UNITED STATES PATENT AND TRADEMARK OFFICE

APPLICATION NO.	FILING DATE	FIRST NAMED INVENTOR	ATTORNEY DOCKET NO.	CONFIRMATION NO.
10/802,899	03/16/2004	Shinichi Yamada	13869.28US01	4637

Office Action Summary

DETAILED ACTION

【図2】

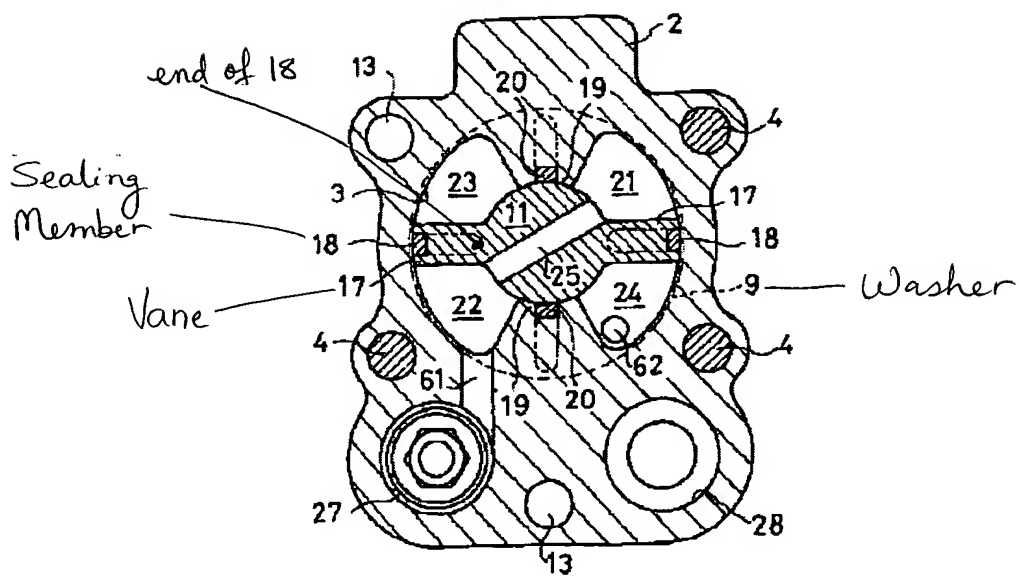
Re: claim 1, Yamamoto shows a rotary damper, as in the present invention, comprising: a housing 2, 5, 6; a fan-shaped oil chamber 22, 23 formed in the housing; a vane 17, on the left, dividing said oil chamber into two chambers 22, 23, a shaft 11 rotatably fastened to said housing and fixed to a base part of the vane such that said vane extends only in one direction, to the left, away from said base part; a seal part, as

described below, provided on said based part dividing in a fluid-tight manner between a bearing rotatably supporting said shaft on said housing and said two chambers, wherein the oil chamber generates a damping force by passing operation oil between said two oil chambers when said vane oscillates, said seal part comprises a pair of washers 9, 9, sandwiched between an inner face of the housing of said two chambers and the base part, as shown, and a sealing member 18 provided to at least portions of 3 edges of said vane which seals in a fluid-tight manner between said vane and the inner face of said housing; said sealing member having ends with the ends facing said base part of said vane contacting edge peripheries of said washers so as to seal in a fluid-tight manner therebetween, as marked below and as described in paragraph [0026] wherein the seal member 18 is to cover the sides and the end face of the vane 17 as shown in the figure below. Please note how the term "periphery" is being interpreted in the Response to Argument section below. Note also that each washer 9 is of a doughnut shape having an inner periphery and an outer periphery. As shown in figure 2, the ends of sealing member 18 contact the inner peripheries of washers 9, 9.

Re: claim 3, Yamamoto further discloses interconnected fitting grooves are formed in each part of said vane facing the inner face of said two chambers, and said sealing member is fitted and secured in said fitting grooves in page 3, paragraph [0026] and as illustrated in phantom lines in figure 2 above.

Re: claim 4, Yamamoto shows said base part to be located between said fitting grooves and said shaft in figure 2 with the phantom line on vane 17 representing the fitting grooves.

Re: claim 8, Yamamoto shows a rotary damper, as in the present invention, comprising: a housing 2, 5, 6 with a fan-shaped oil chamber 22, 23; a shaft 11 rotatably fastened to said housing and fixed to a base part of a vane 17, on the left, said vane extending away from said base part into said fan-shaped oil chamber to divide said fan-shaped oil chamber, as shown above; and means for sealing among said shaft, said housing, and said vane, said sealing means including a sealing member 18 mounted on a portion of said vane, said sealing member sealing between said vane and said

housing, said sealing member having ends facing said shaft, as marked above, said sealing means also including a pair of washers 9, 9 mounted about said shaft in contact with said housing and extending into said oil chamber, said washers having edge peripheries, said ends of said sealing member contacting the edge peripheries of said washers to provide a seal among said washers, said housing and said vane, as explained above.

5. Applicant's argument is more specific than the claim language. Applicant argues that Yamamoto does not show a fan-shaped chamber and a vane extending only in one direction. Looking at figure 2 of Yamamoto, one can see clearly that the left portion of Yamamoto's damper shows the claimed fan-shaped chamber and vane 17 extending only to the left direction to divide the fan-shaped chamber into two chambers 22 and 23. Applicant has not provided any limitation in the claim to exclude a plurality of the claimed chamber and vane. Applicant also argues that Yamamoto's sealing member 18 does not contact the edge peripheries of the washers 9, 9. The definitions of the term "periphery" are provided below. Using definition #1 of the term "periphery" and definitions #1a, 1b and 2 of the term "perimeter", one can see that the ends facing the base part of sealing member 18 of Yamamoto contact the inner edge peripheries of washers 9, 9.
